**Bodie Hills RV Park  
Revised Specific Plan &  
Final Environmental Impact Report (FEIR)**

**SCH# 97012031**

**January 2000**

**Mono County Community Development Department  
P.O. Box 347  
Mammoth Lakes, CA 93546**

Figure 4 -- RV Park and Motel/General Store/Rental Office

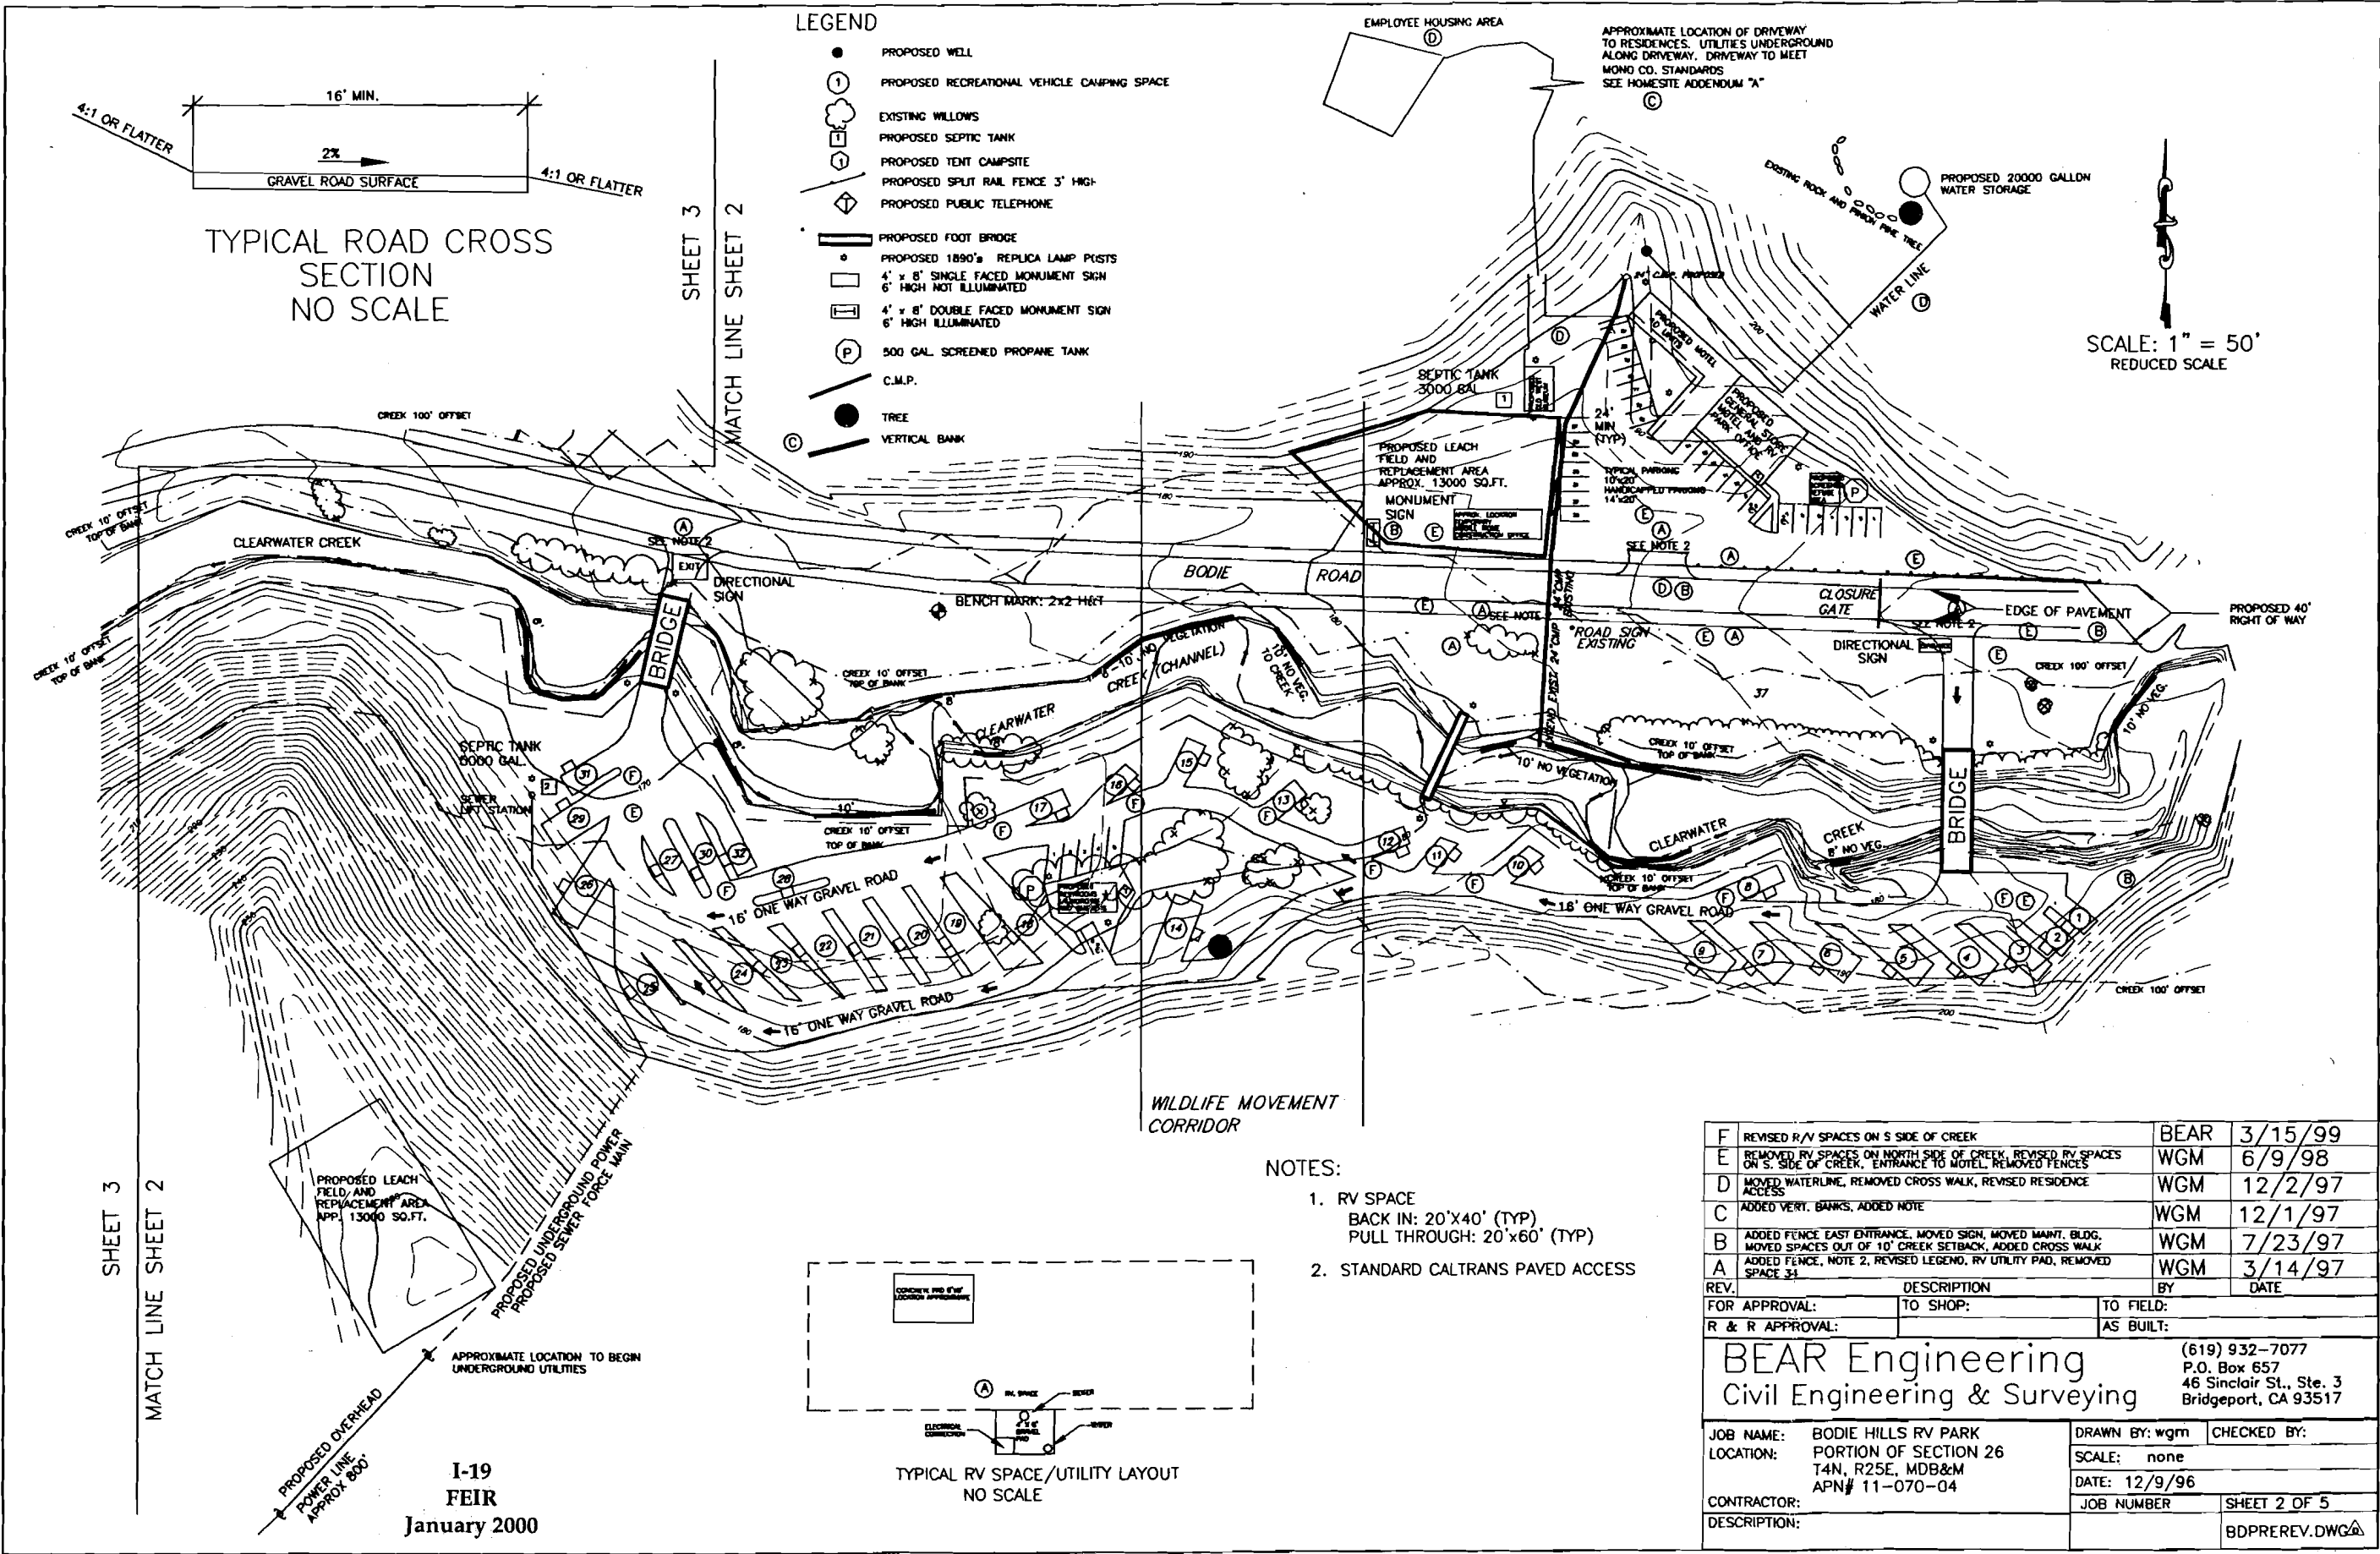
Figure 4 indicates that RV space 8 and a maintenance building to the east (labeled B) are both intruding into the 10' setback. Also, a number of the RV spaces (10 to 17) (using a scale of 1" = 100' derived by measuring the Bodie Rd.) are NOT 20' x 40' as indicated in the text. In earlier project maps the spaces were indeed 20x40. Will the project ultimately be constructed so that the sites are 20x40, thereby intruding into the no development zone? Or will some sites be smaller than others?

Desert Survivors supports establishment of this. However, on Figure 4 it appears to be 50' wide rather than the designated 150'.

According to Figure 4, the wildlife movement corridor encompasses all of sites 13, 14 and 15, and bisects portions of 12 and 16. Five RV vehicles spaces should be closed during migration, not three.

I noticed also some inconsistencies on DEIS Figure 4 with the text of the document. Figure 4 shows RV space 8 and the maintenance building to the east located right up to the edge of the creek bank, inside the 10 foot setback space in violation of Specific Plan Policy 5 (p. 24). In addition to RV spaces 13,14 and 15, portions of spaces 12 and 16 are located on Figure 4 within the Wildlife Movement Corridor in violation of Specific Plan Policy 8 (p. 25). And finally, Figure 4, along with all the other figures using the same basemap, has the wrong scale noted on the map. As I pointed out to you in a letter last Feb. 10th and as I showed on the figures in my report (Appendix B), the correct scale is not 1" = 50', but rather 1" = approximately 100'.

*Figure 4 will be amended to correct the inconsistencies noted above. The DEIR contains an alternative (Alternative 2, Reduced Project) which requires a 30 foot setback and which reduces potential impacts.*

*Figure 4 of the DEIR is a reduction of a 1" = 50' map; the scale is distorted in the reduction process.*
